DULUTH, MINNESOTA  
January 25, 2021

## ADDENDUM No. 2

### FOR UMD Natural Resources Research Institute (NRRI) Reroof Project UMD PROJECT #: 03-569-20-2122

**1 OVERALL ROOF PLAN**  
A101  
1/8" = 1'-0"

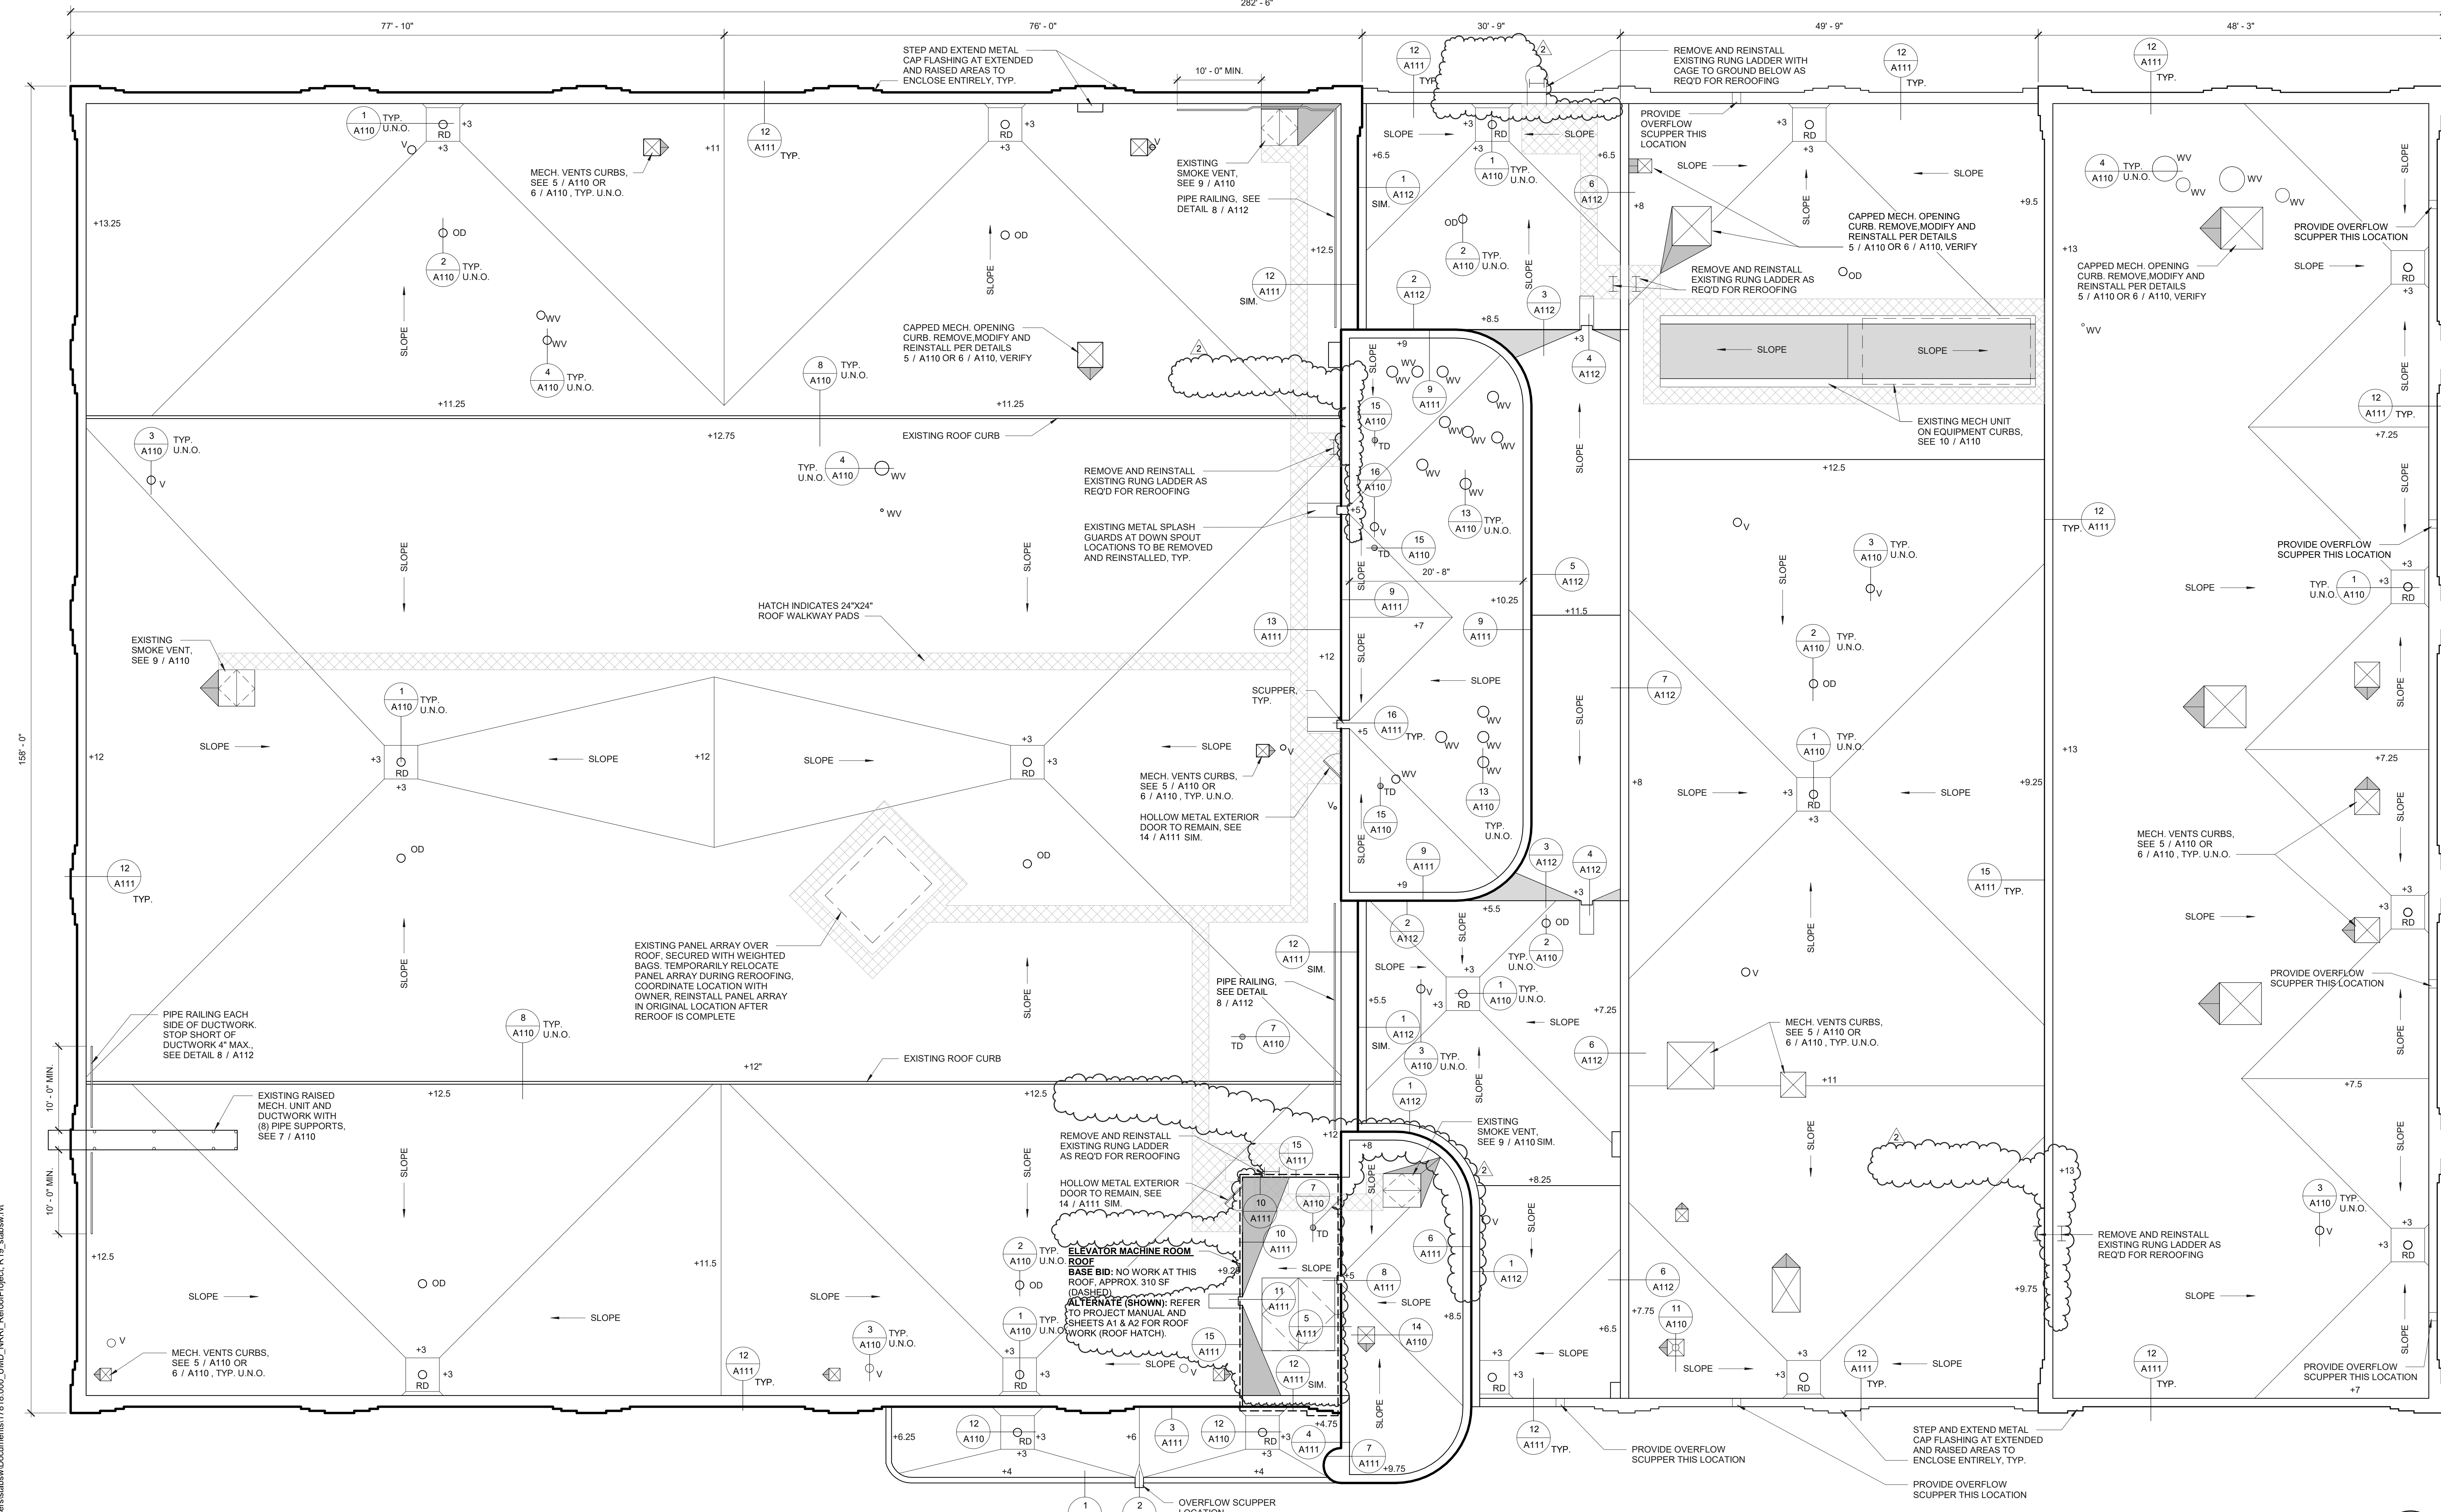
1. On sheet "A100 – GENERAL NOTES AND ROOF REFERENCE PLAN", under the "ROOF ASSEMBLIES" heading, revise (4) instances of "MULTI-PLY BUILT-UP ROOF WITH AGGREGATE BALLAST" TO READ "MULTI-PLY BUILT-UP ROOF WITH AGGREGATE AND FLOOD COAT".
2. Remove sheet "A101 – ROOF PLAN", and replace with attached revised sheet "A101 – ROOF PLAN".
  - a. Roof plan updated to show alternate (not base bid)
  - b. Guards removed at existing roof ladders where not required.
3. Remove sheet "A112 – ROOF DETAILS", and replace with attached revised sheet "A112 – ROOF DETAILS".
  - a. Parapet guard detail revised to be parapet mounted.
